TO: Jeff Weeder, Galloway and Company
FROM: Amber Wood Hicken, Planner I
DATE: 4/27/23
SUBJECT: Lincoln Professional Park L3 – Andy’s Custard, Site Plan, SP23-113
Review Comments 03

LINCOLN PROFESSIONAL PARK FILING NO.1 LOT 3

SITE PLAN DOCUMENTS

2 BUILDING ELEVATION - FACING SOUTH FACE (ROAD A)
 1/4" = 1'-0"

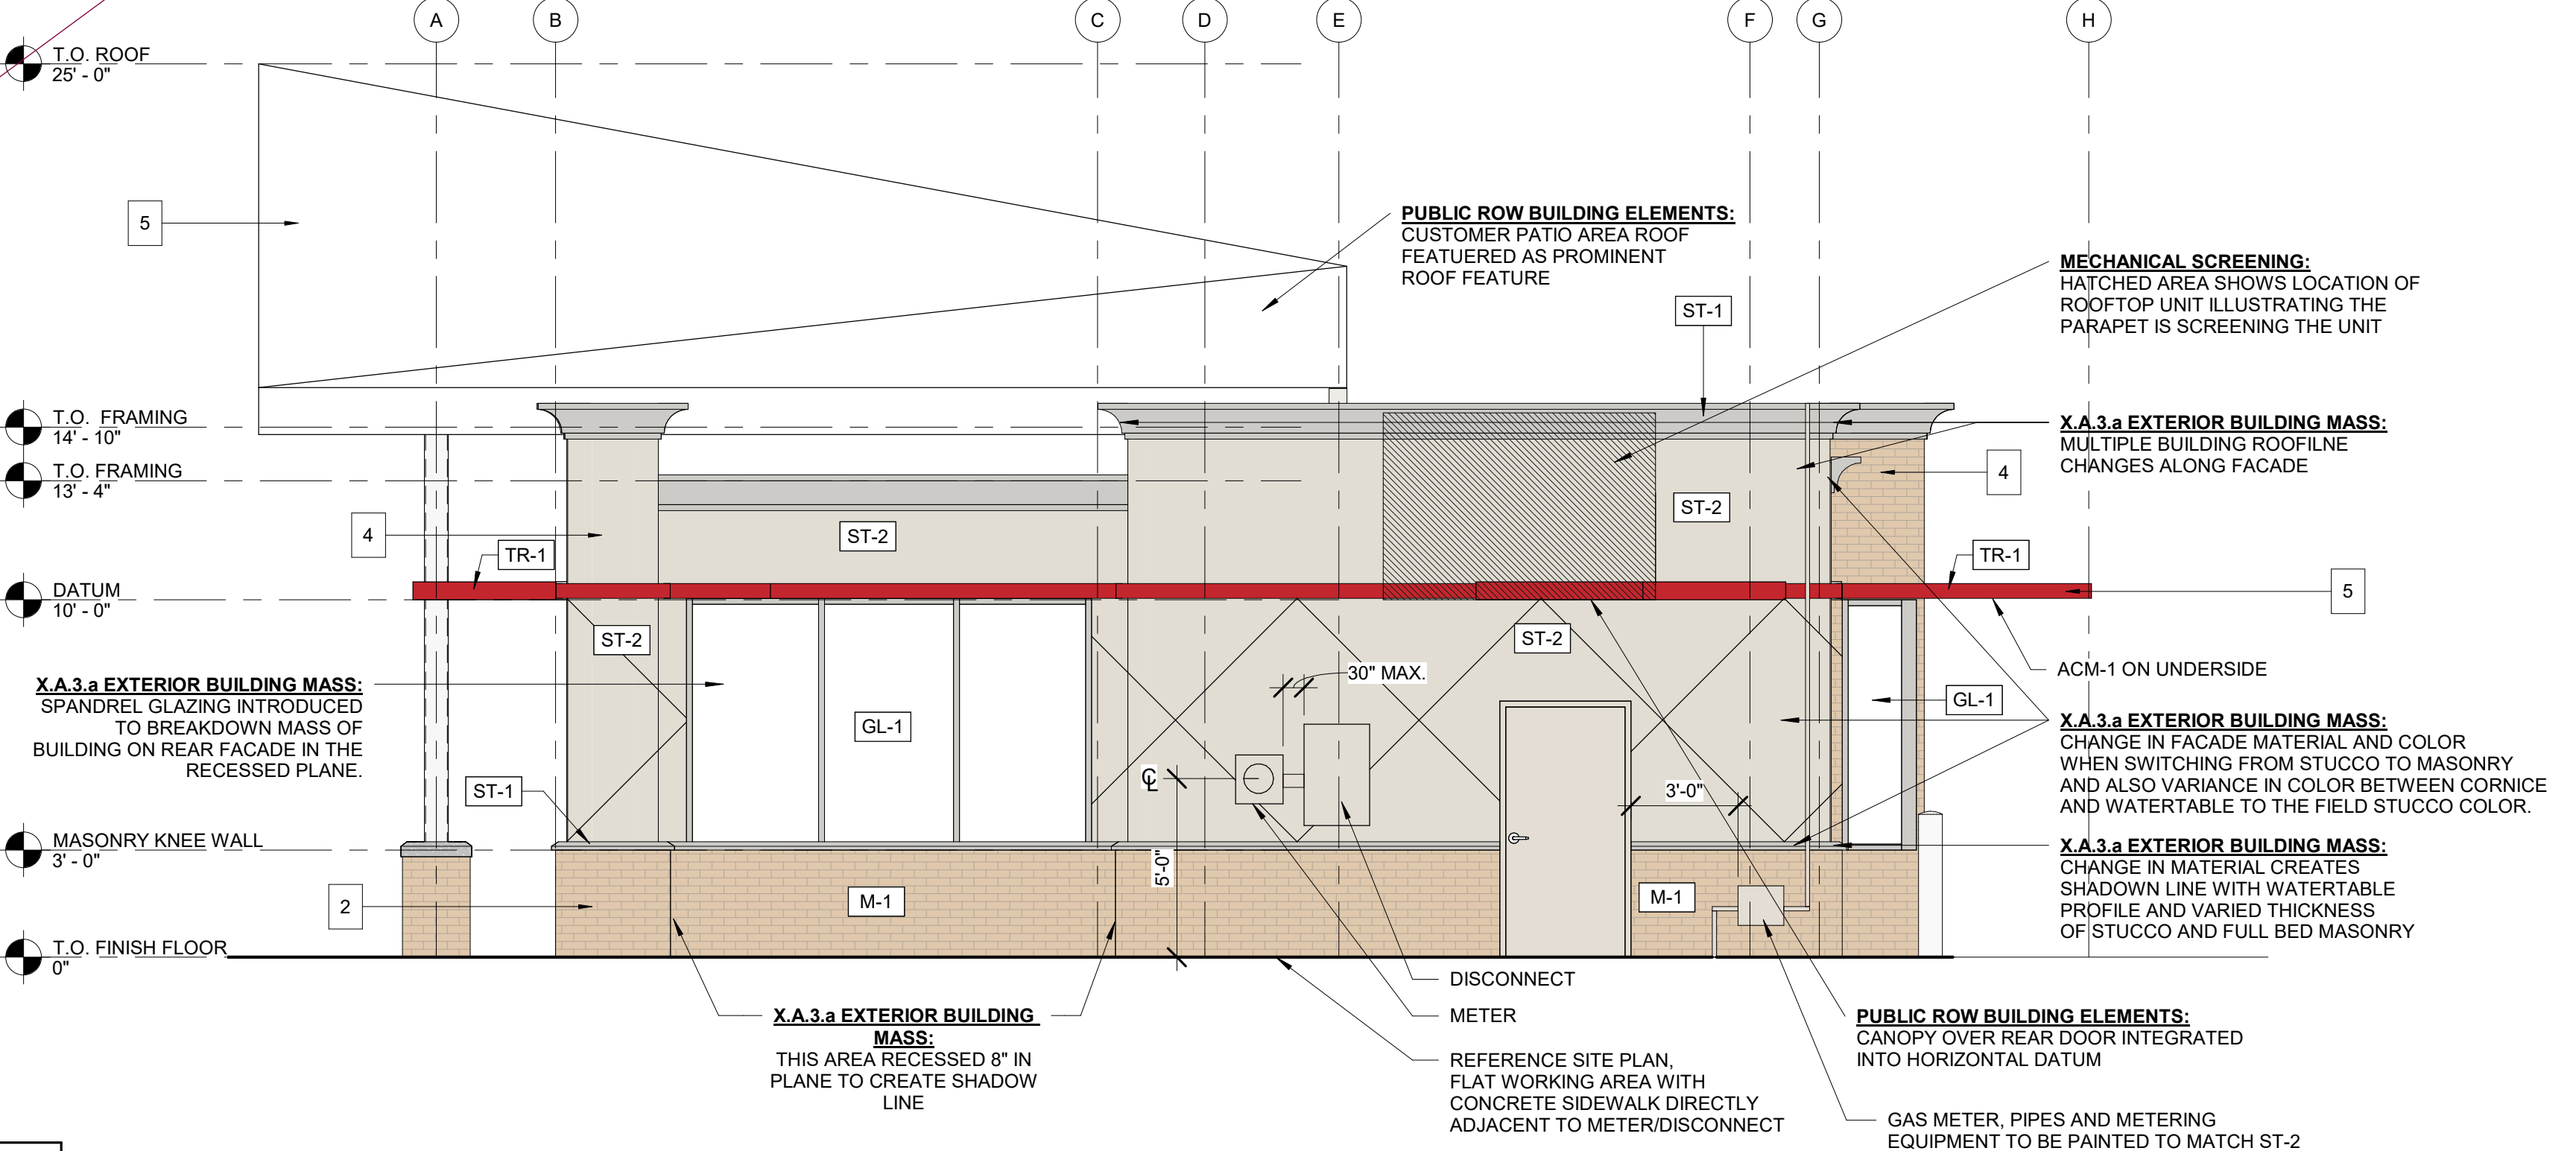
Building must be broken down horizontally (top to bottom) with a base, middle, and top. The middle should include:
 a) Visibly apparent material change
 b) String courses (horizontal banding)
 c) Stepbacks, recesses or protrusions
 DDS, pg 52

Building must be broken down vertically (left to right), requiring three (3) of the following:
 1) A change in recesses, protrusions, or changes in the plane of the facade of the building sufficient to create a visible shadow line (see figure 71).
 2) A significant break in the eave line or roof form
 3) A change in facade material or color
 DDS, pg 53

Response: Per email conversation with city planners the design has been adjusted to include a more substantial watertable for transition between the brick and stucco applications. Stucco control joints have been enlarged from 1/2" to 1" reveals and the brick application has been amended on the rear elevation to include full brick to the decorative cornice where glazing exists.
